SUBJECT: Forwards response to RA Gilbert 870113 request for addl info re emergency response capability, per open items identified in interim rept on conformance to Rev 2 of Reg Guide 1.97. Selected pages from updated FSAR also encl.

Re: Duane Arnold Energy Center, Docket No. 50-331  
Subject: Emergency Response Capability - Conformance to R.G. 1.97,  
Rev. 2: Response to Request for Additional Information  
Reference: R.A. Gilbert letter to L. Liu dated January 13, 1987  
File: A-370

RESPONSE TO OPEN ITEMS:  
CONFORMANCE TO REGULATORY GUIDE 1.97

Radiation Zones - Elevation 855 Ft  
Figure 12.3-5

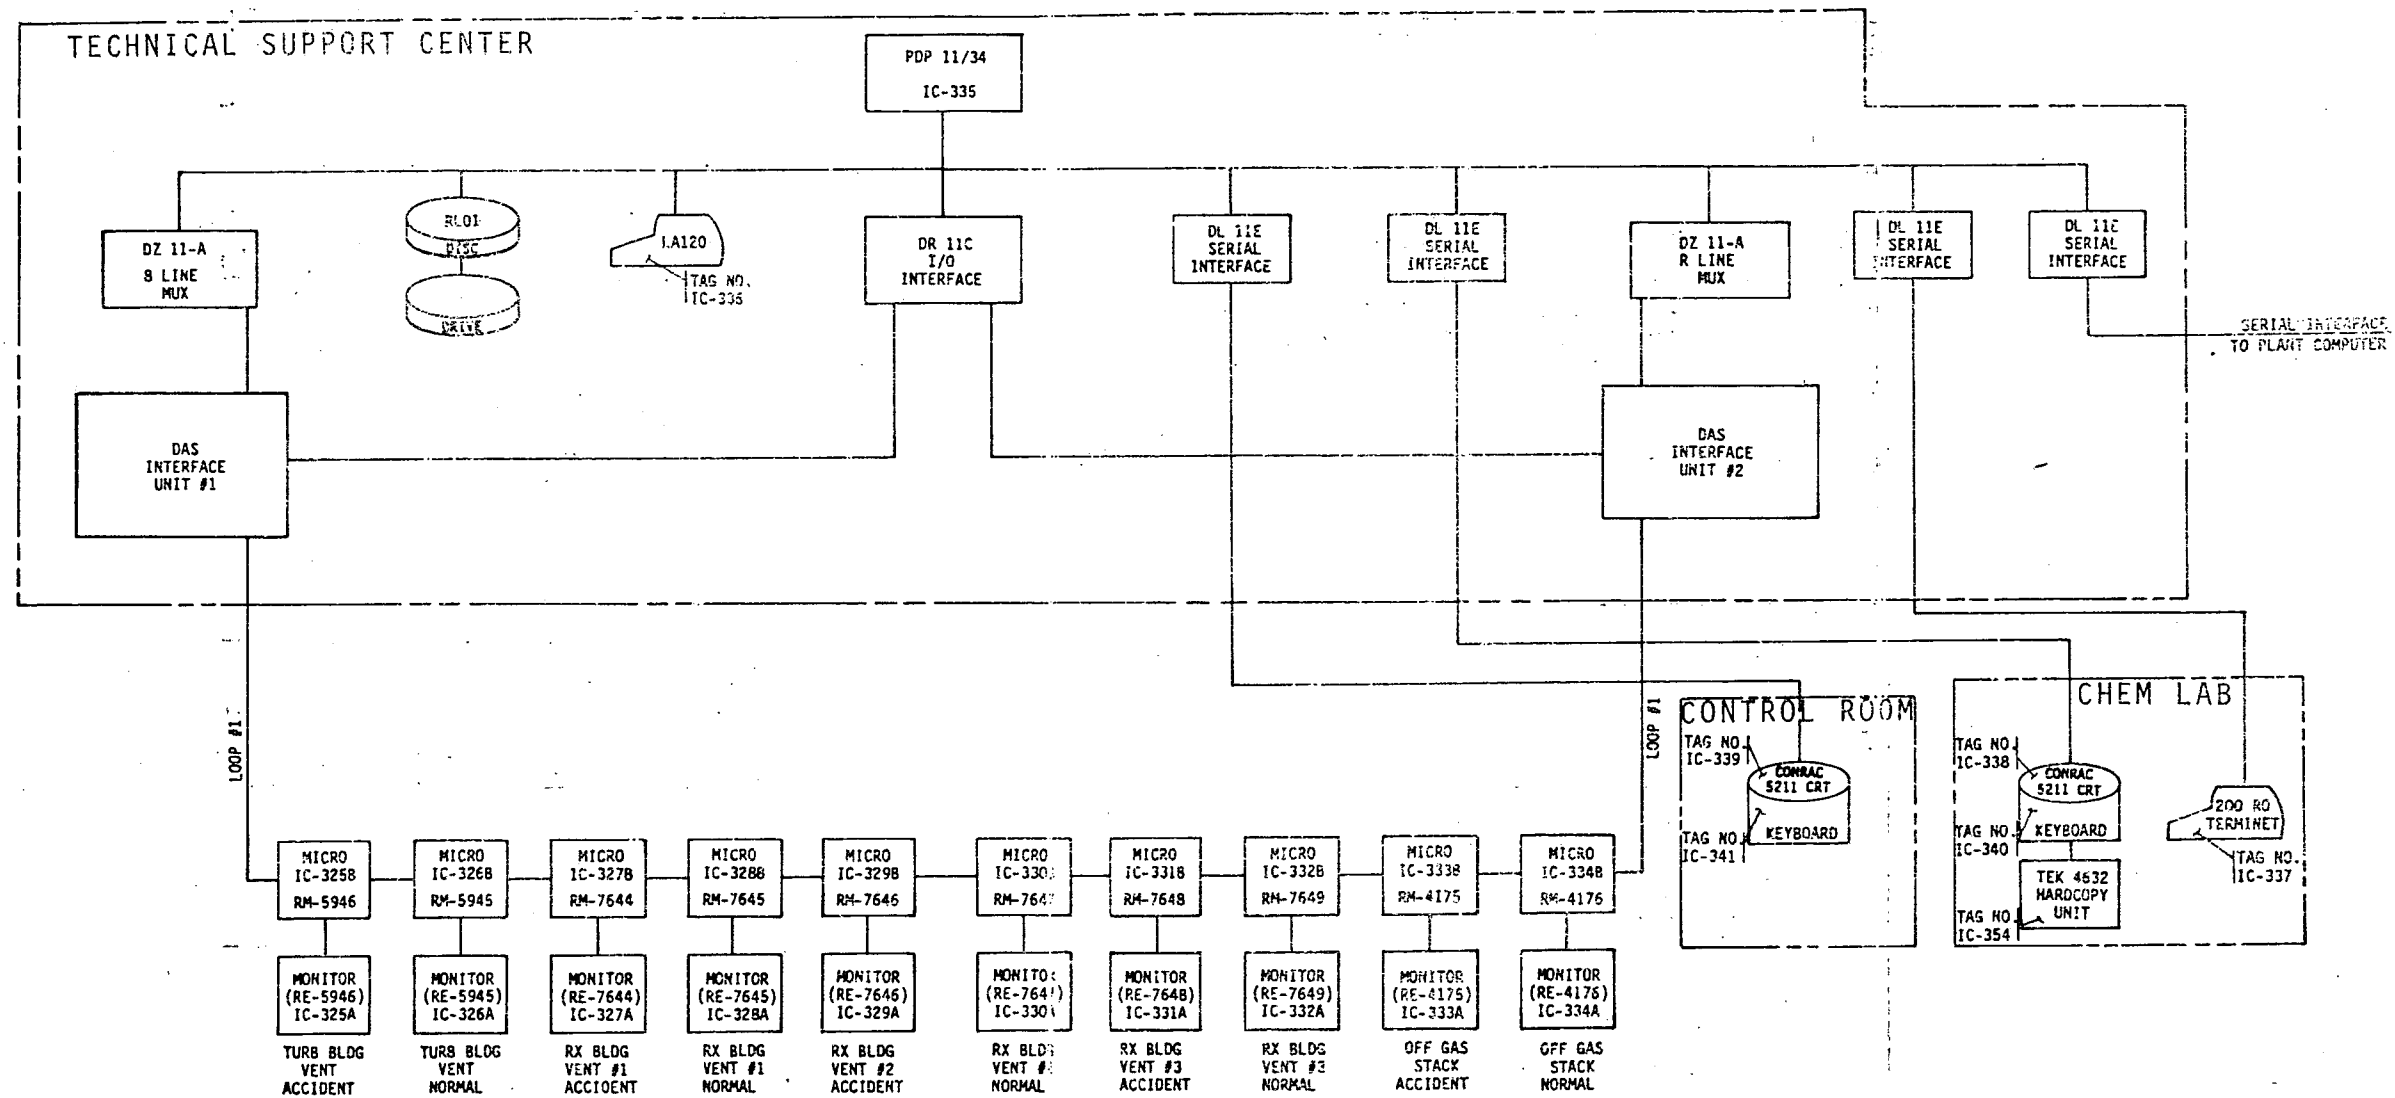
*"The licensee has not shown analysis of radiation levels expected for the monitor locations. The licensee should show that the existing radiation exposure rate monitors have ranges that encompass the expected radiation levels in their locations."*

Radiation levels expected in various areas of the plant during normal operation are outlined in Section 12.3.1.1 of our FSAR (reference 5 - copy attached). Detailed maps of these areas are provided in Figures 12.3-1 through 12.3-5 of our FSAR. Our area radiation and airborne radioactivity monitoring instrumentation is described in Section 12.3.3 of our FSAR. The location and range of each instrument in our area radiation monitoring system is described in Figure 12.3-7 of our FSAR. The purpose of our area radiation monitoring system is to warn of abnormal gamma radiation levels within the plant. Each instrument is selected to cover the full range of radiation levels expected during normal operation plus at least two decades above the maximum rate expected during normal operation. They are not intended to cover the full range of post-accident radiation levels. If the radiation level exceeds the range of a particular instrument under post-accident conditions, that instrument would still provide a warning of abnormal radiation levels at the monitor location by reading upscale.

Extended Range Airborne Effluent Radiation  
 Monitoring System  
 Figure 11.5-5

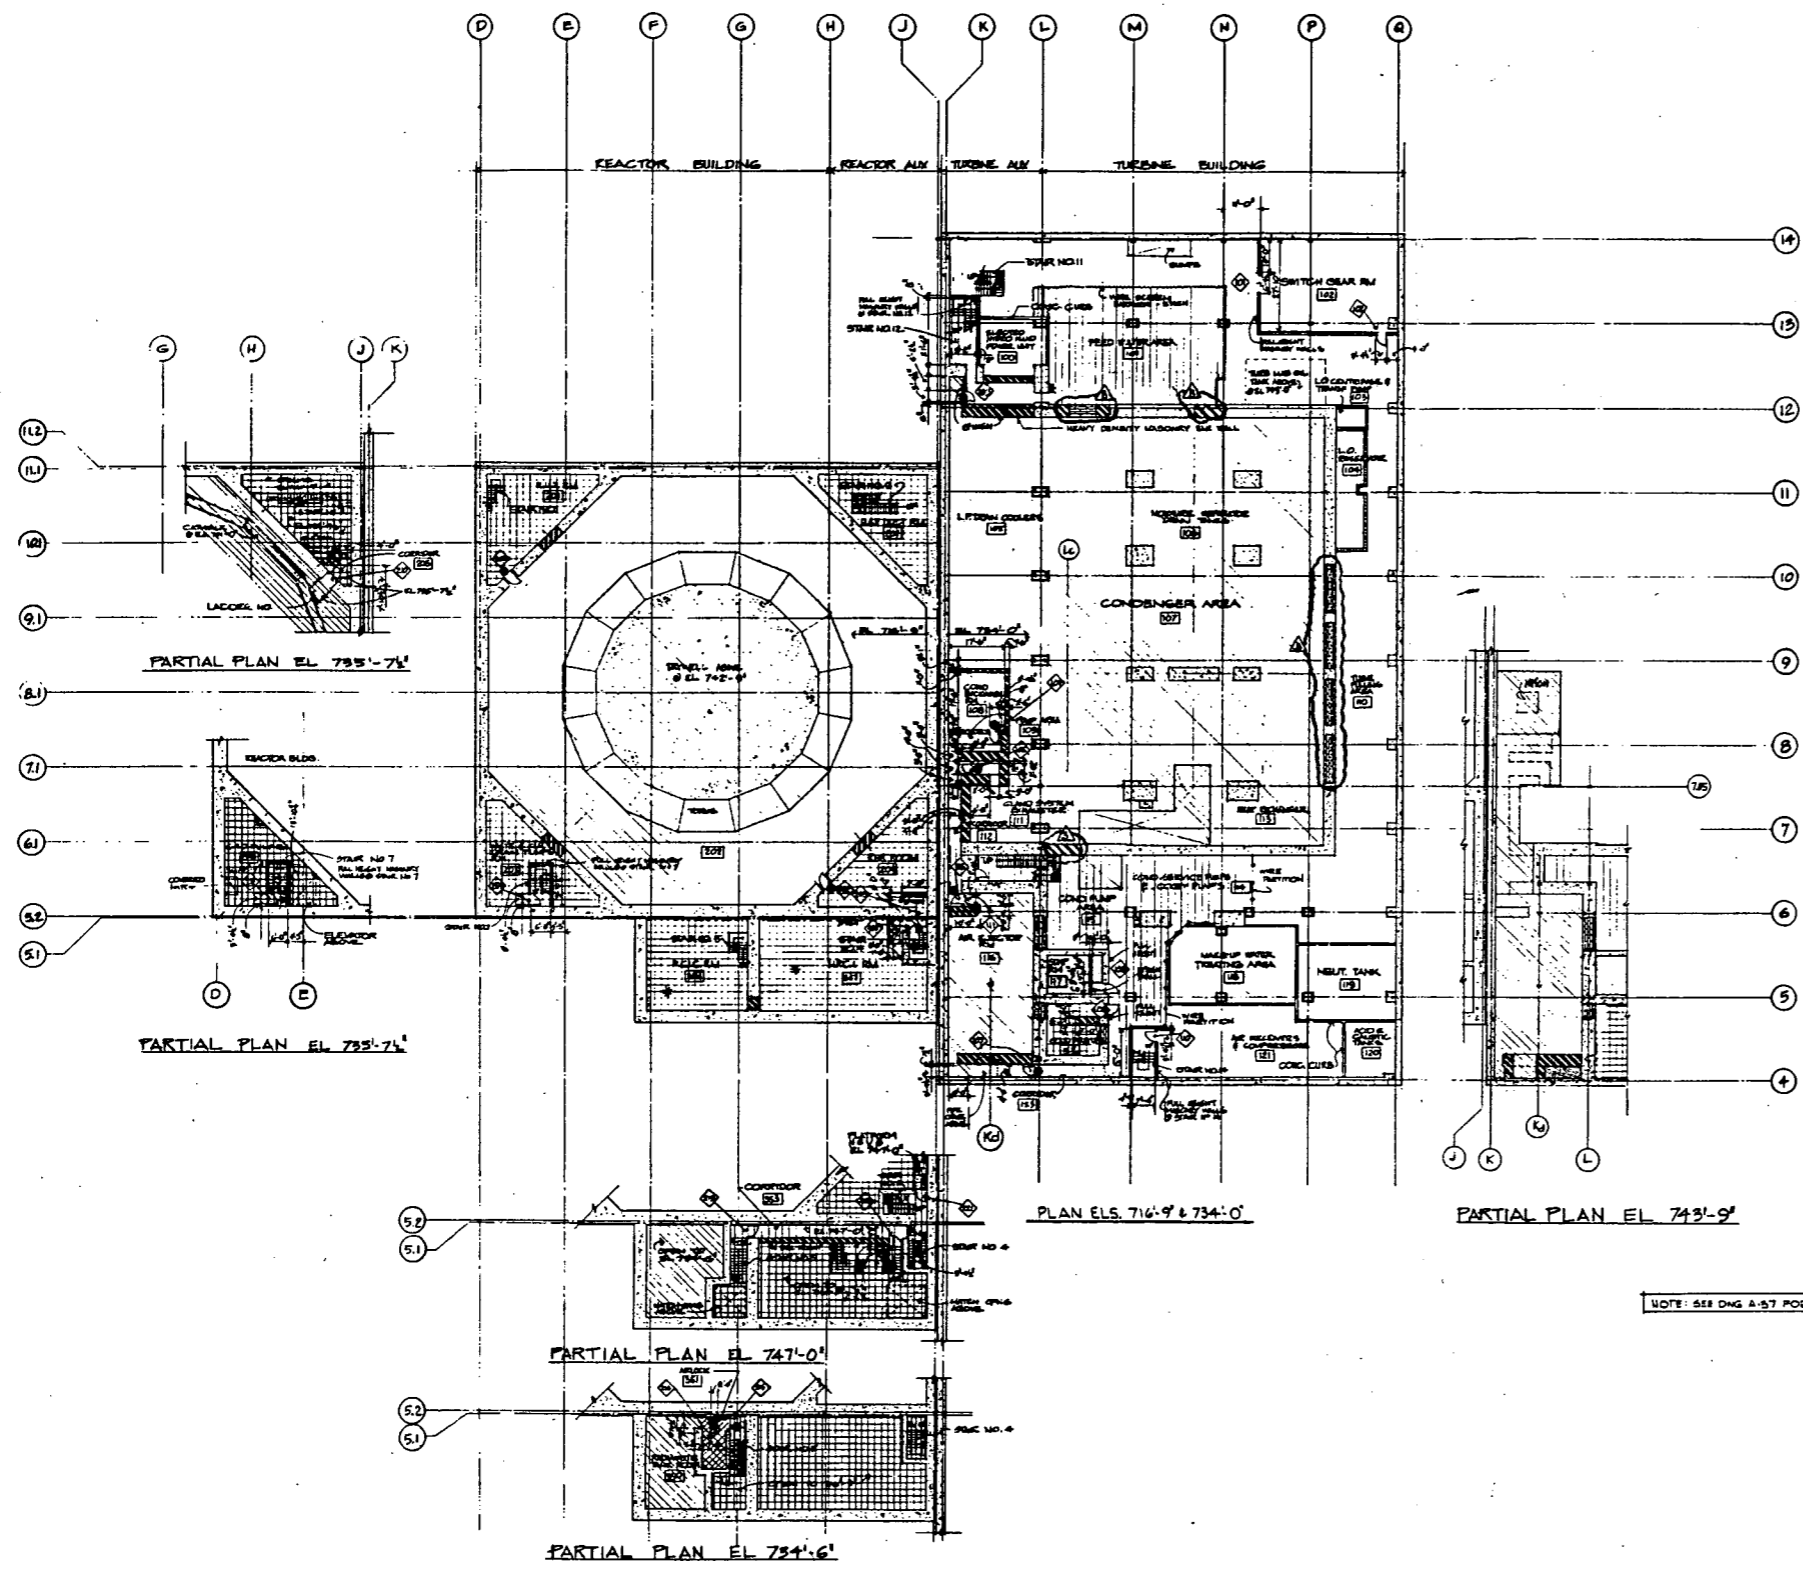
*"The licensee states that the instrumentation for this variable is not needed, as the noble gas effluent monitors are more useful and practical in detecting or assessing primary containment leakage. This is due to the radioactivity in the fluids flowing in the emergency core cooling systems piping, and the large number of piping and electrical penetrations and hatches between the primary containment and the reactor building. For the Mark I containment, the recommended range is  $10^{-1}$  to  $10^4$  R/h. The licensee has not shown how the recommended range is met by the noble gas effluent monitors."*

The extended range airborne effluent radiation monitoring system described in Section 11.5.9 of our FSAR is a more effective system for the detection of significant releases, release assessment, and long-term surveillance than the area radiation monitor system. The airborne effluent radiation monitoring system covers the range of  $10^{-7}$  to  $10^5$  uCi/cc for noble gases. This is three decades greater than the  $10^{-6}$  to  $10^3$  uCi/cc range recommended in Regulatory Guide 1.97 for noble gas effluent monitors.
